CALL NO. 100  
CONTRACT ID NO. 161033  
ADDENDUM # 3

Subject: Magoffin County, TGR 0061 (064)  
Letting June 24, 2016

- (1) Revised - Plan Sheets - S1, S14, S15, R2V, R41 & R159
- (2) Revised - Bid Items - Pages 714-726 of 726
- (3) Added - Special Note - Pages 1-10 of 10

### MOUNTAIN PARKWAY (KY9009) OVER BURNING FORK STA. 3934 + 37.58

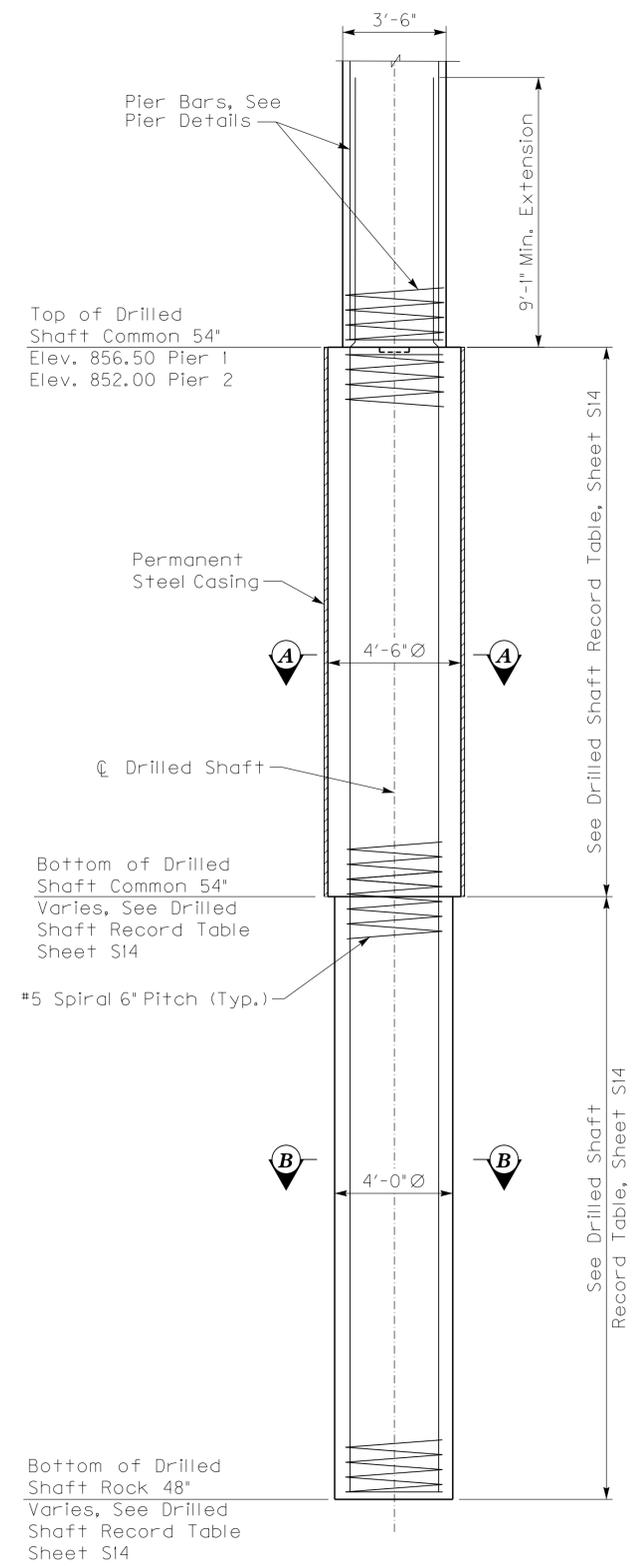
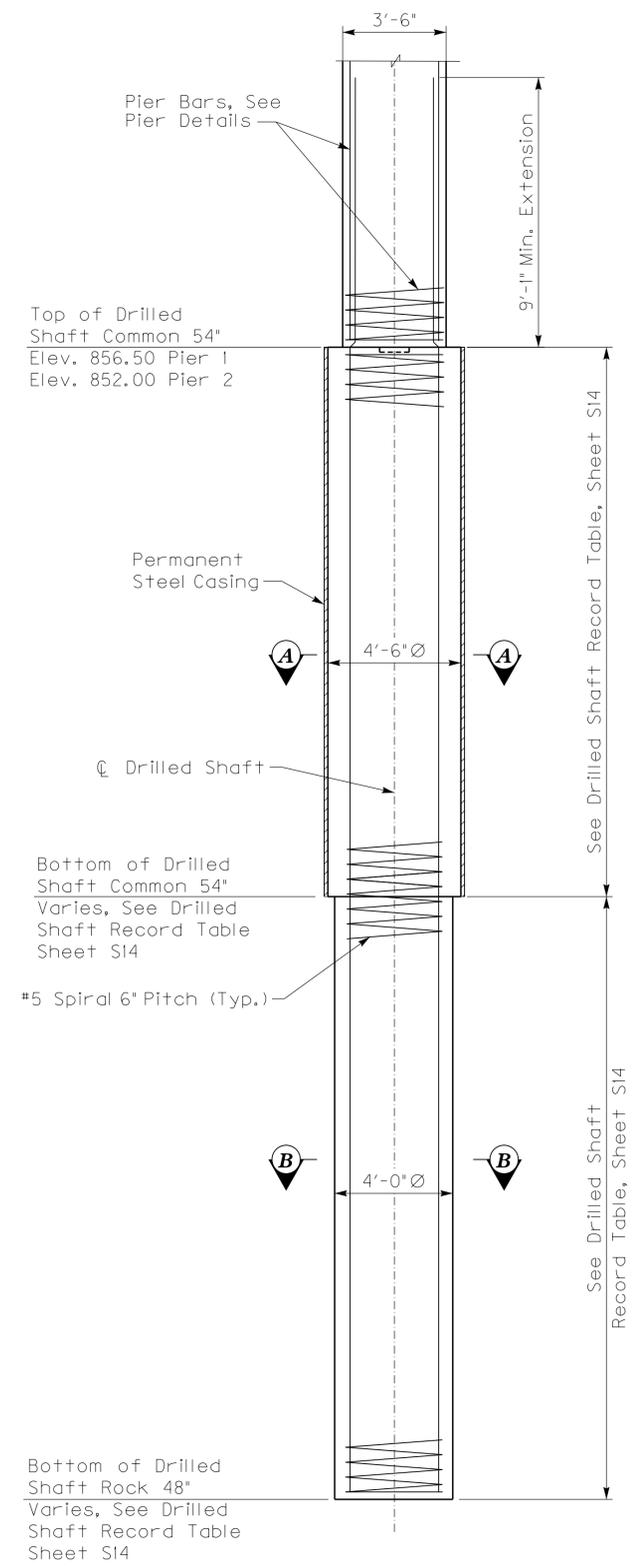
- 2) Contrary to the Special Note for Drilled Shafts, construction cores will not be required at the Pier 1 and Pier 2 drilled shaft locations. Rock cores obtained during the geotechnical exploration were drilled at the center of each shaft and extend deep enough to cover the embedment length.

- 3) Permanent casing is required in the overburden. Permanent casing is incidental to the unit bid price for "Drilled Shaft 54 inch (common)".
- 4) Reinforcement cages shall be held centered in the rock socket and adjusted as necessary to match plan location at the bottom of the pier column.
